Ref: Response to request for review of "Jincheng Sihe Coal Mine CMM Generation Project" (1896)

In response to the request for review of "Jincheng Sihe Coal Mine CMM Generation Project" (1896), we bring to your kind attention the following initial clarifications and responses.

Figure 1 - Flows diagram and monitoring points at Sihe mining site.

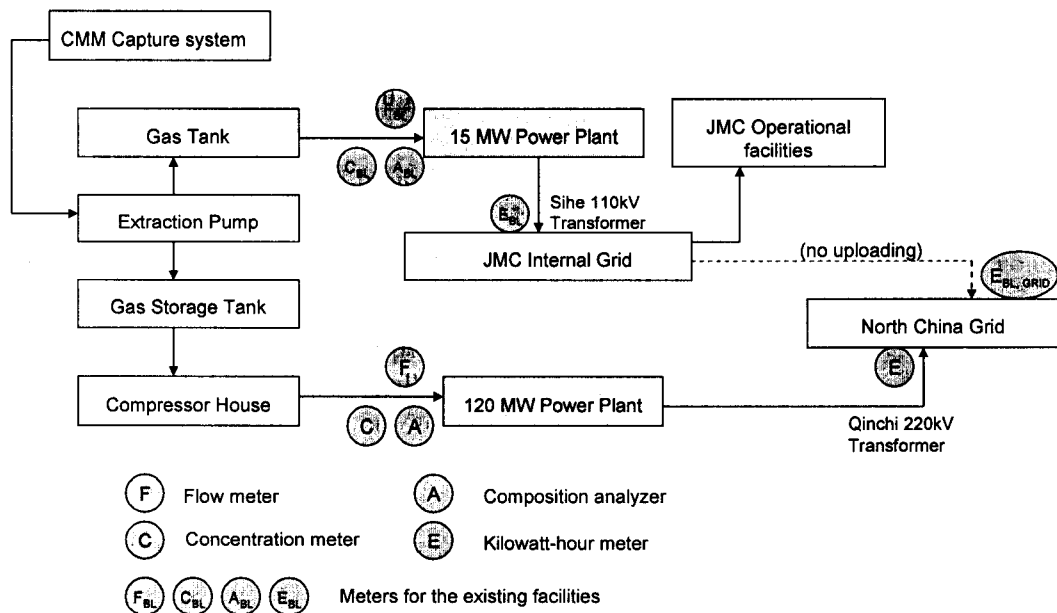
3. The PP/DOE should further clarify the following monitoring information:

- (a) power generation and CMM consumption by the existing experimental 15MW power plant;**
- (b) details of checking the flow and concentration meters;**
- (c) consistency with the monitoring methodology in monitoring of methane fraction in CMM gas;**
- (d) monitoring of electricity to be supplied to and imported from the grid for the project activity.**

3a. Power generation and CMM consumption by the experimental 15MW power plant

The existing experimental 15MW power plant utilizing CMM at the Sihe mine generates electricity for the internal need of the Sihe mine (captive usage by JMC operational facilities). The electricity generated is supplied through the JMC internal 110 kV grid through the Sihe 110kV transformer station (please see Figure 1).

The electricity flows from 15MW and 120 MW power plants are separate: The JMC internal grid is connected to the North China Grid to comply with the Chinese grid requirements (however no uploading to the grid is taking place). The JMC internal grid is connected to the North China Grid in the point different from the Qinchi 220 kV transformer station (which is used as the monitoring point for the 120 MW plant as clarified below in 3d).

The figure 1 represents the generic diagram of flows and monitoring points of the new power plant and the existing 15MW experimental power plant.

To monitor power generation and CMM consumption of the existing experimental 15MW power plant, the following monitoring equipment will be used by JMC:

- Electricity metering: electricity meters have been installed at the outlet of the existing 15MW power plant to continuously monitor the electricity generated. The electricity meters at the Sihe 110 kV transformer station are monitoring the electricity supplied to/imported from the internal JMC Power Grid.
- Gas concentration meter: to be installed at the inlet to the existing power plant. This meter will monitor the concentration of the CMM gas sent to the existing 15MW power plant.
- Gas flow meter: to be installed at the inlet to the existing power plant to meter the volume of CMM supplied to the existing 15 MW power plant.
- Separate meters to measure respectively the temperature and pressure of the CMM sent to existing power plant will be installed.
